Volume II
of the
Final EIS/EIR for the
Van Ness Avenue BRT Project

Appendices I & J

Response to Comments

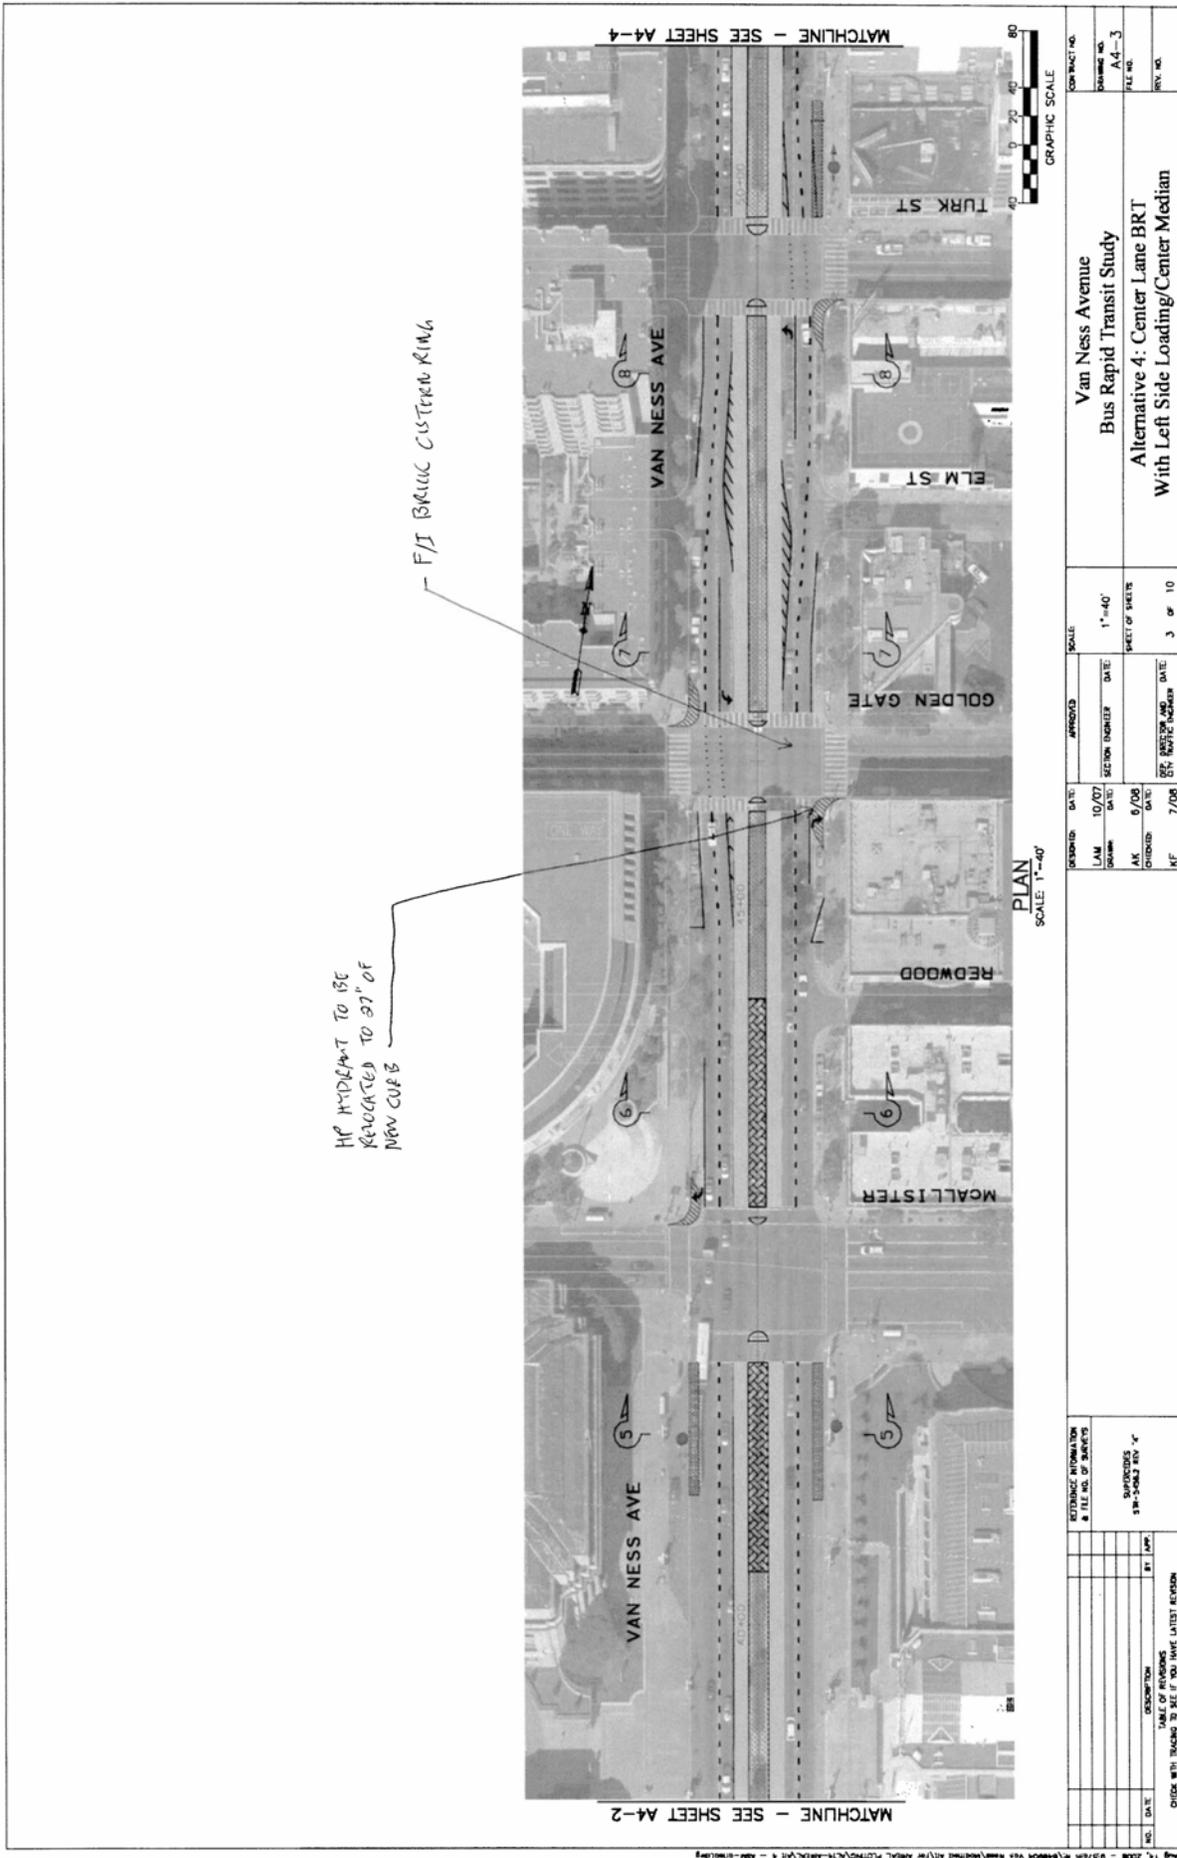
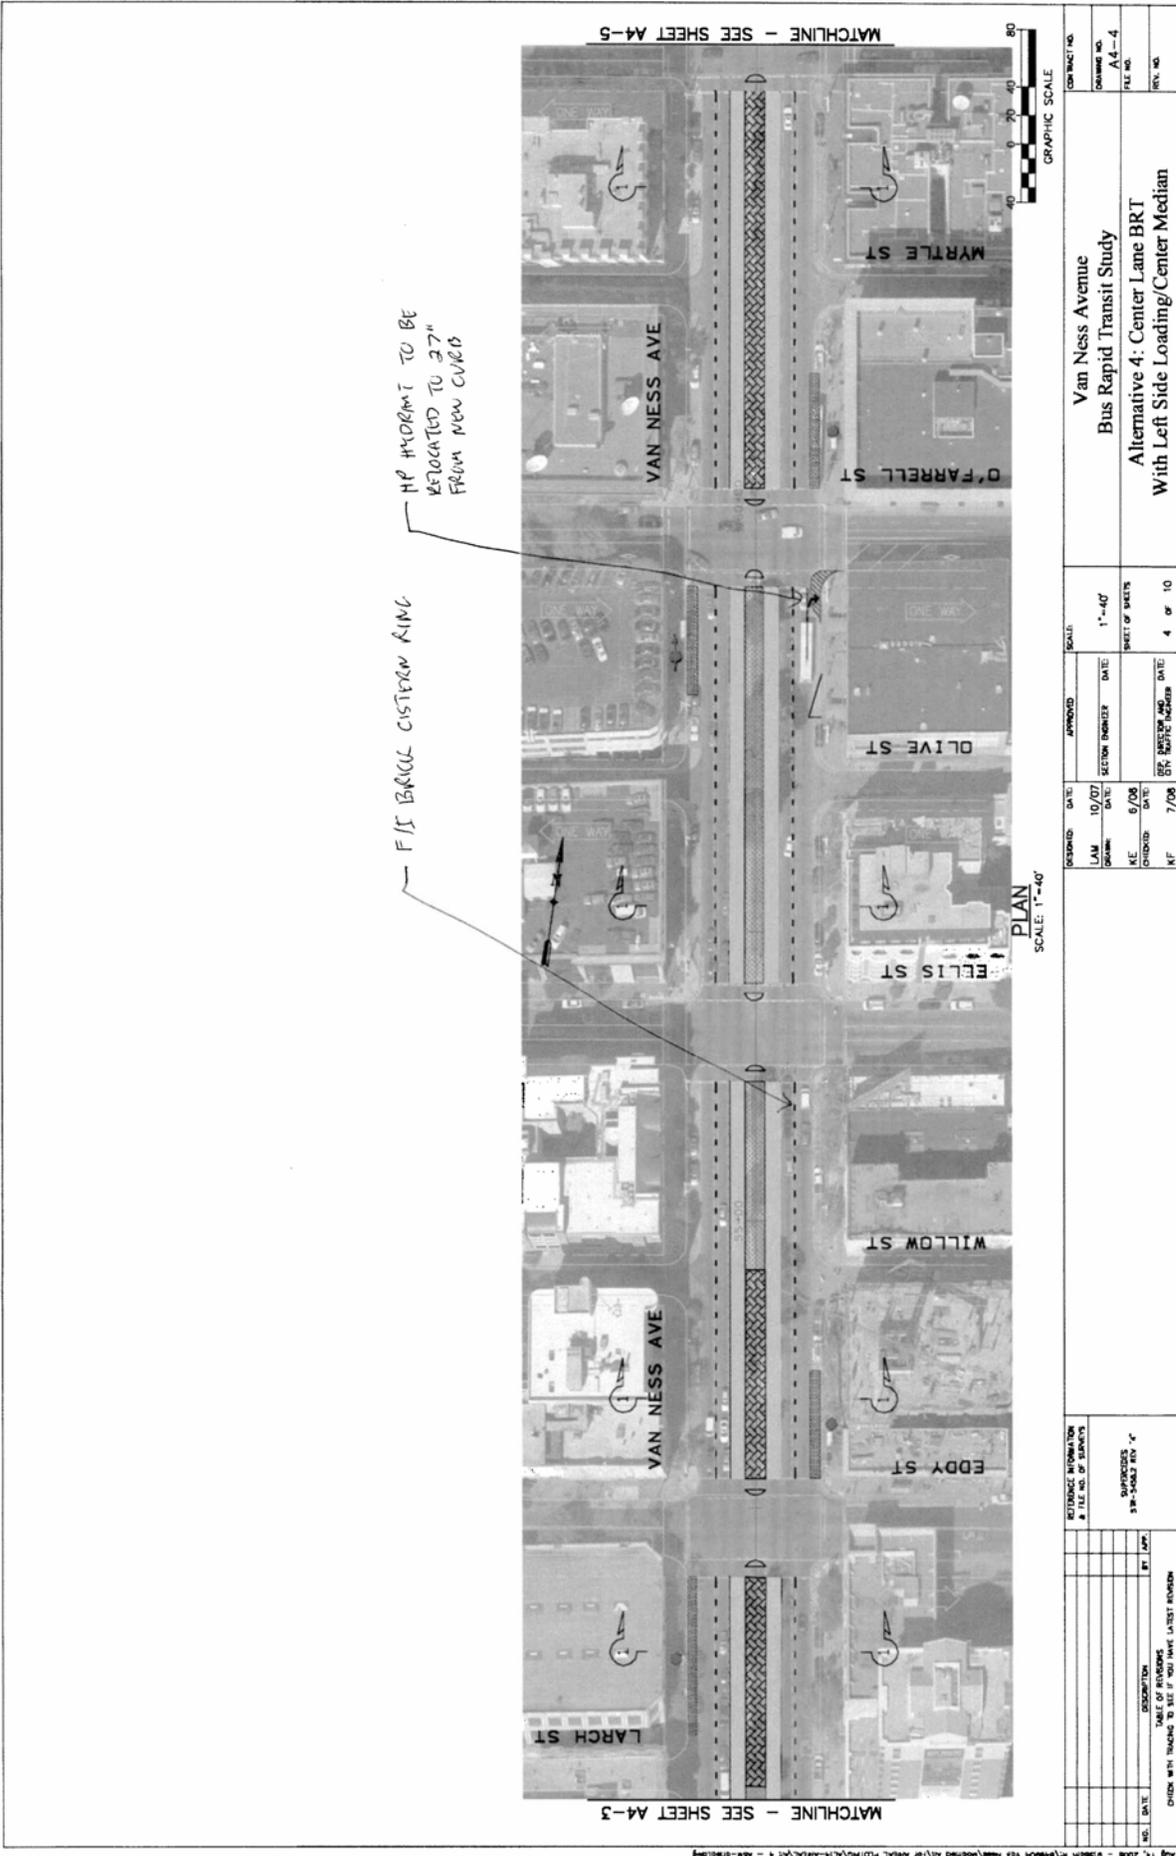
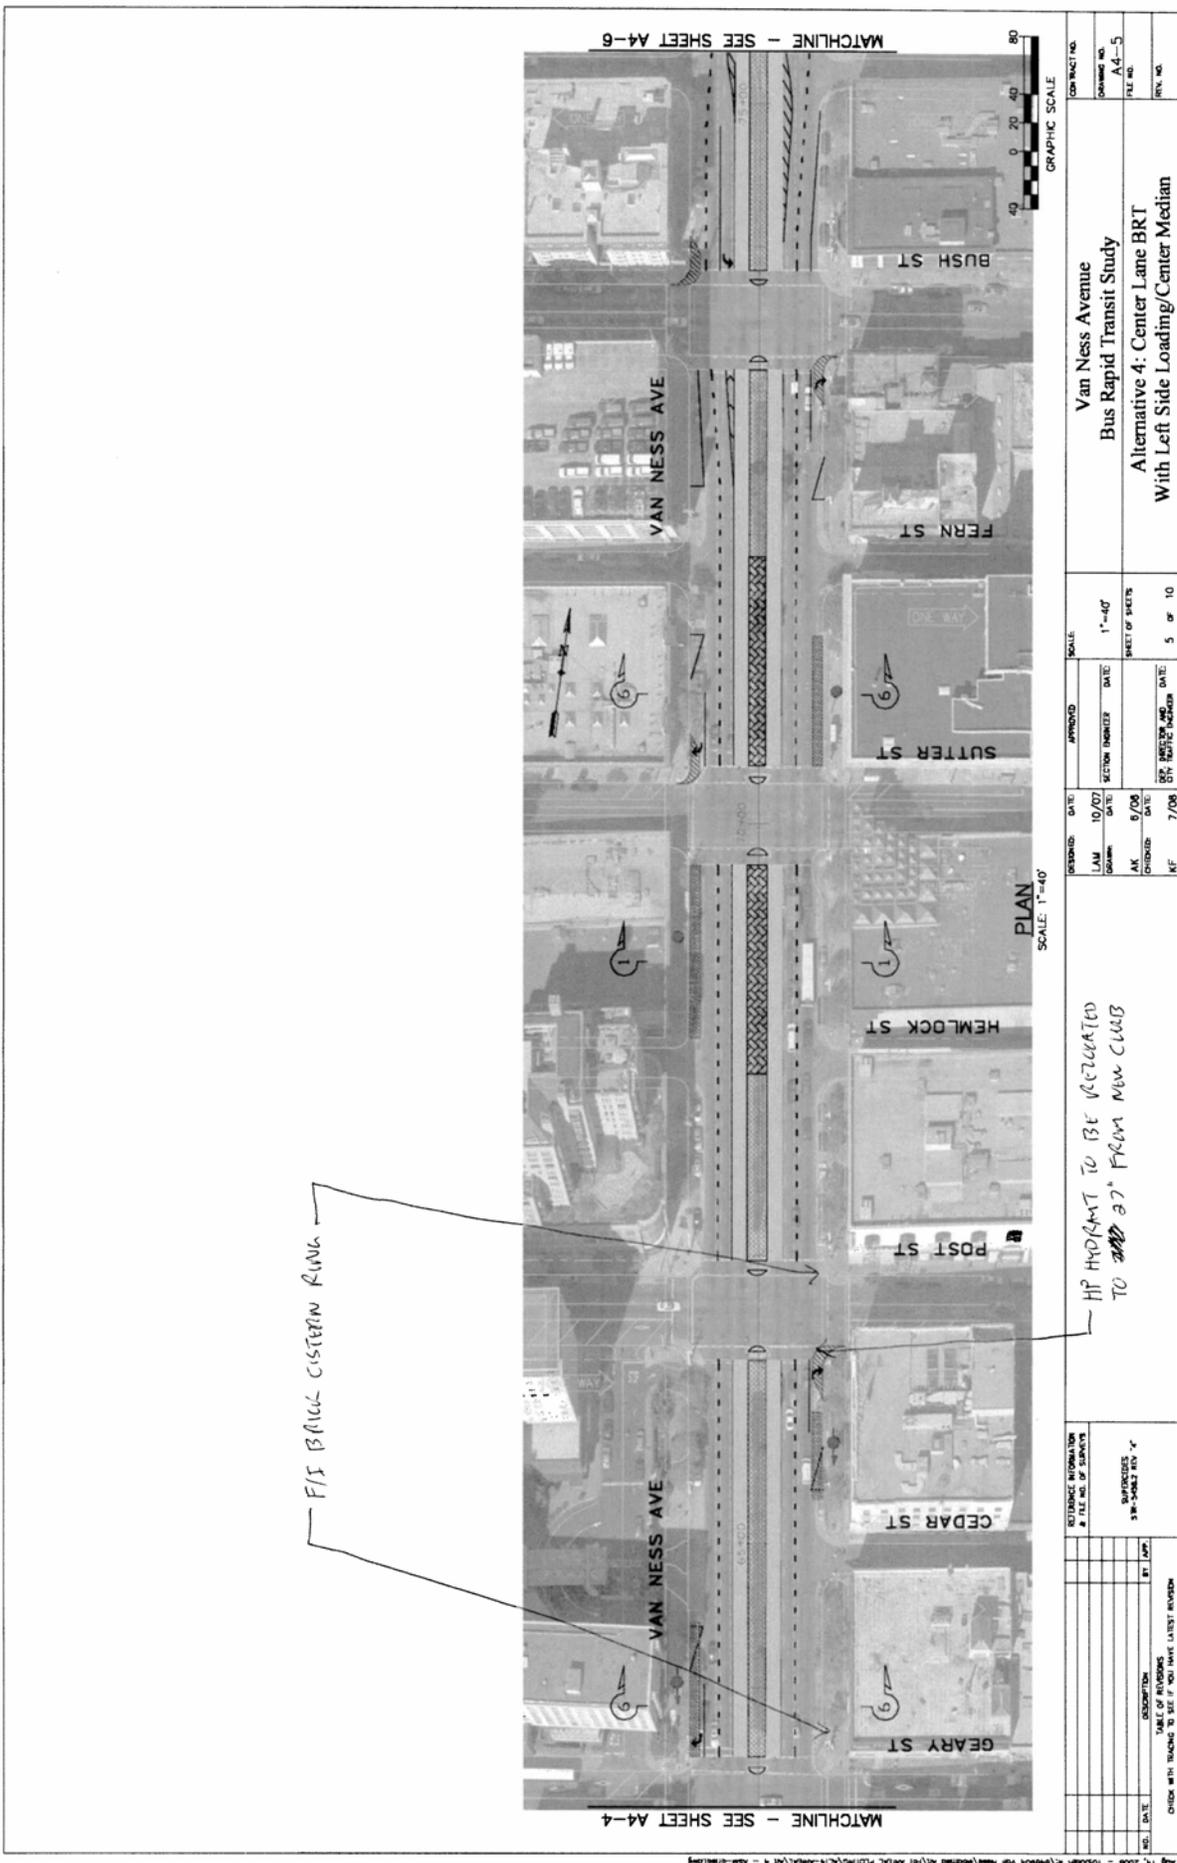
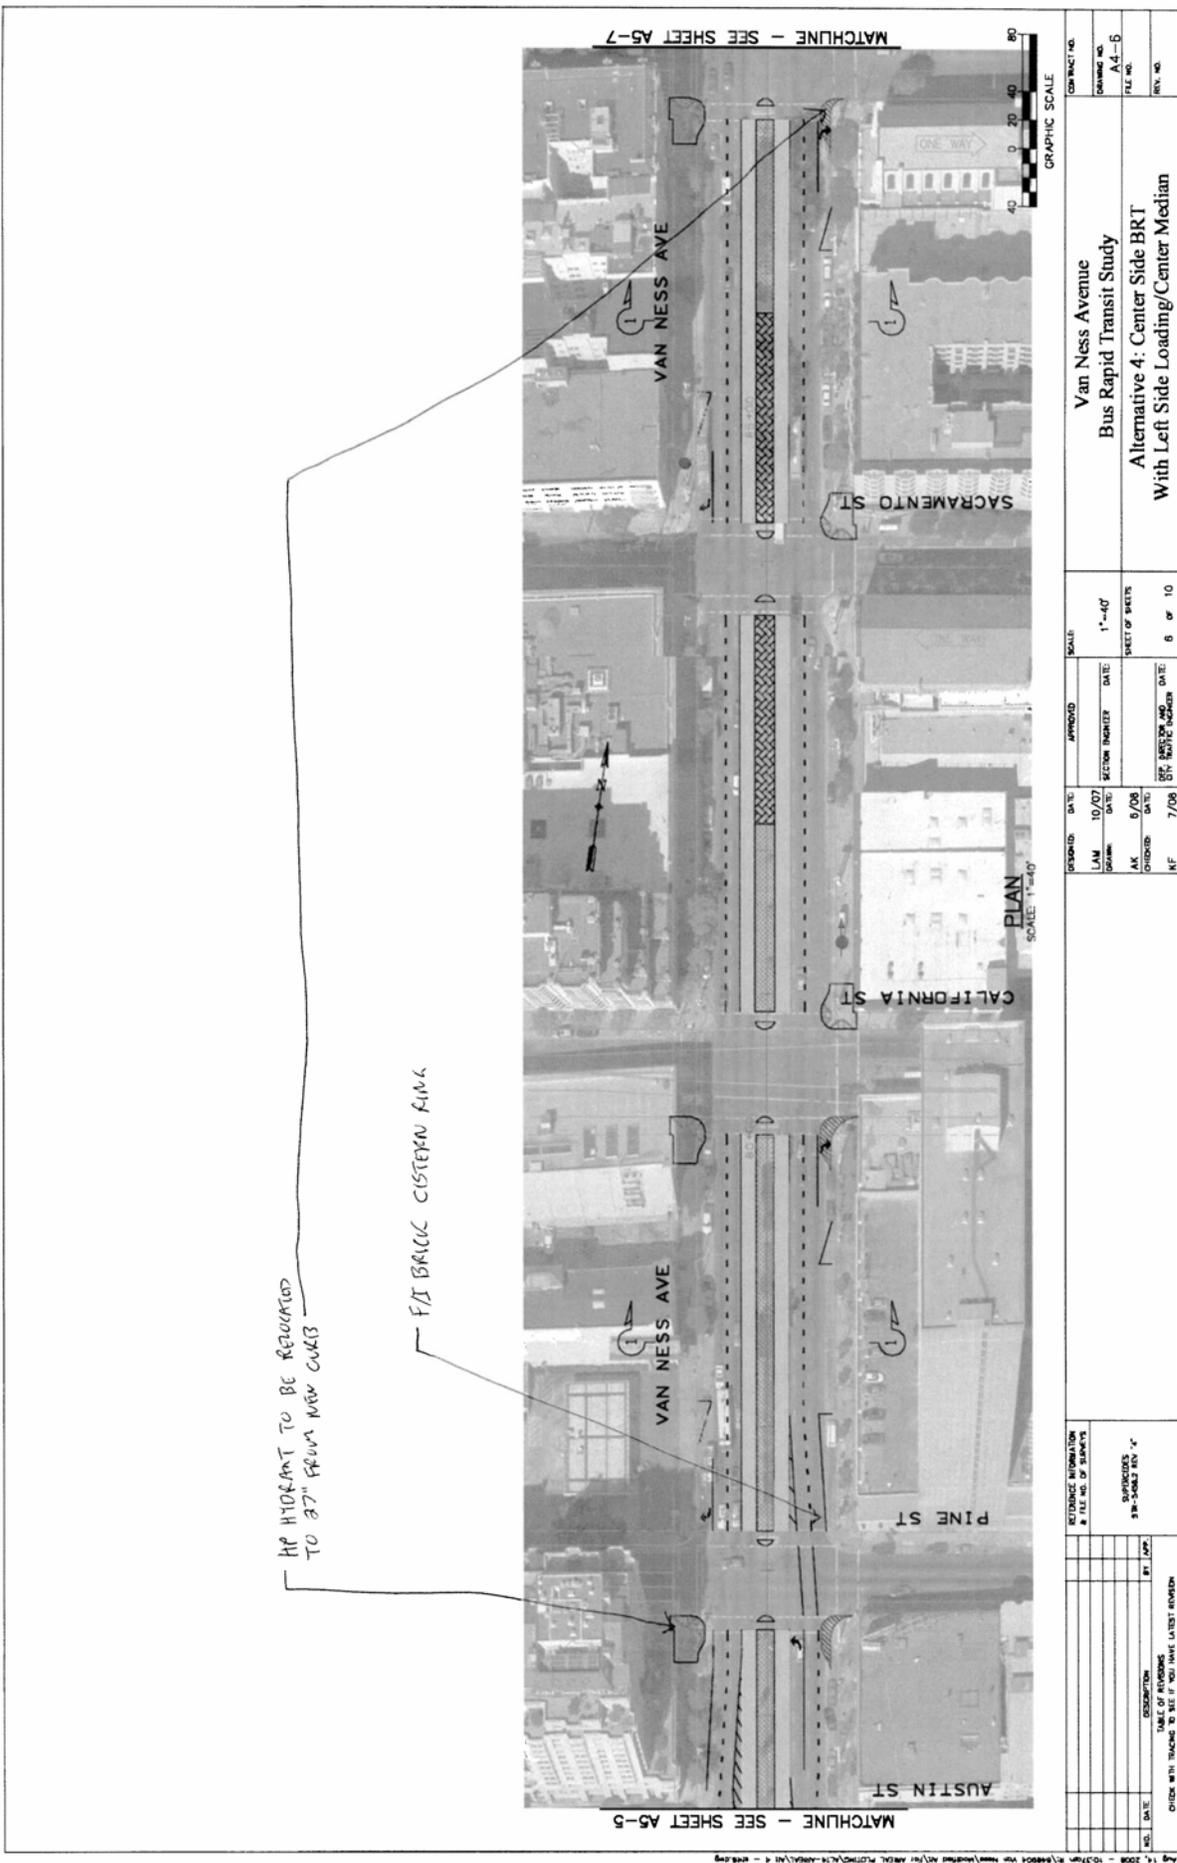
HP HYDRANT TO BE
RELOCATED TO 37' OF
NEW CURB

FIT BRASS CISTERNE RING

HP HYDRANT TO BE
RELOCATED TO 27"
FROM NEW CURB

F/S BRICK CISTERNA RING
